CITY OF KELOWNA  
MEMORANDUM

**Date:** October 18, 2006  
**File No.:** OCP06-0019/Z06-0050  
**To:** City Manager  
**From:** Planning & Development Services Department

<b>APPLICATION NO.</b>	OCP06-0019 Z06-0050	<b>APPLICANT:</b>	Neil Denby Runnalls Denby & Associates
<b>AT:</b>	2750 Shayler Court 2880 Shayler Court 2930 Shayler Court 3025 Shayler Court 3099 Shayler Court 3135 Shayler Court 3185 Shayler Court 3215 Shayler Court 3255 Shayler Court	<b>OWNERS:</b>	Steven & Bonnie Cloutier Erwin Braun/Ercon Holdings Ltd. Dave & Moyra Skoglund Leslie Gardner/Klista Redfield Ralph & Tanis Rubini Clark Smith Shane Ginter/Shirley A. Ginter Bob Gruber/616507 B.C. Ltd. Clark Smith/616507 B.C. Ltd.

**PURPOSE:** To amend the Official Community Plan Future Land Use designation from Future Urban Reserve to Rural/Agricultural and to rezone the subject property from the A1 – Agriculture 1 zone to the RR1 – Rural Residential 1 zone to allow a subdivision to create additional rural residential single family lots.

SLOPE ANALYSIS

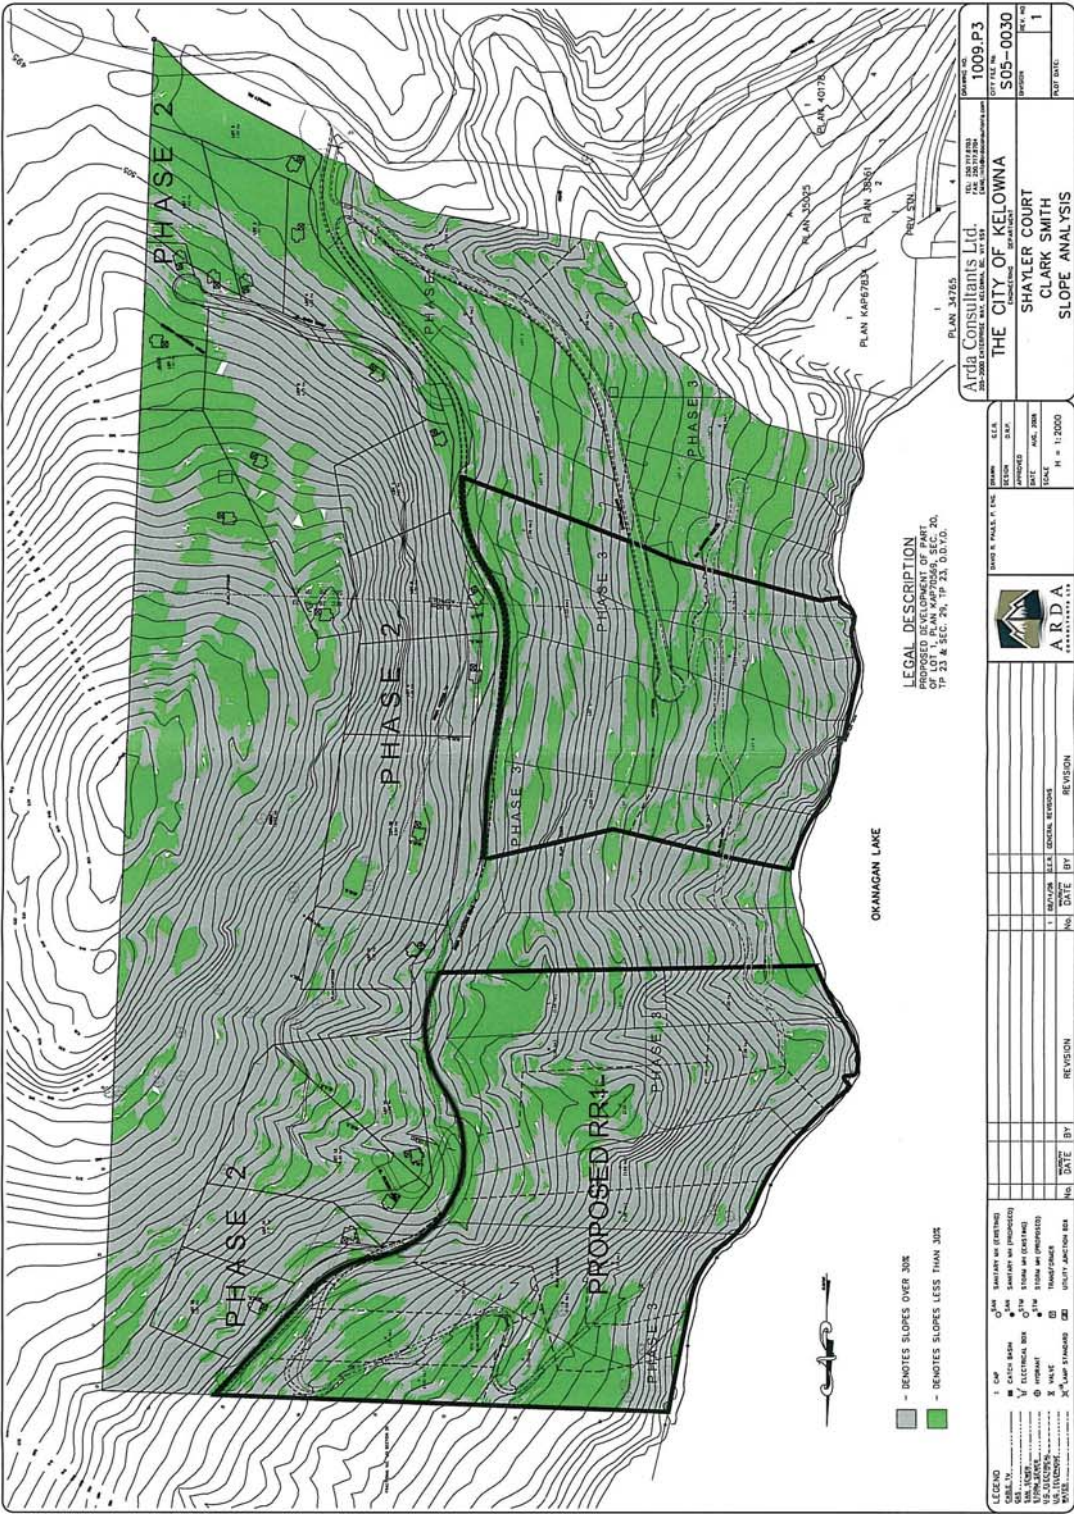
A very high percentage of the lands have slopes well over 30% (see the attached topographical comparison and slope analysis maps) and as such are not conducive for urban types of development. The OCP discourages development on lands with a slope over 30%. Given the topographic conditions of the site, urban densities would generally not be possible other than at the southern most portion of the property.
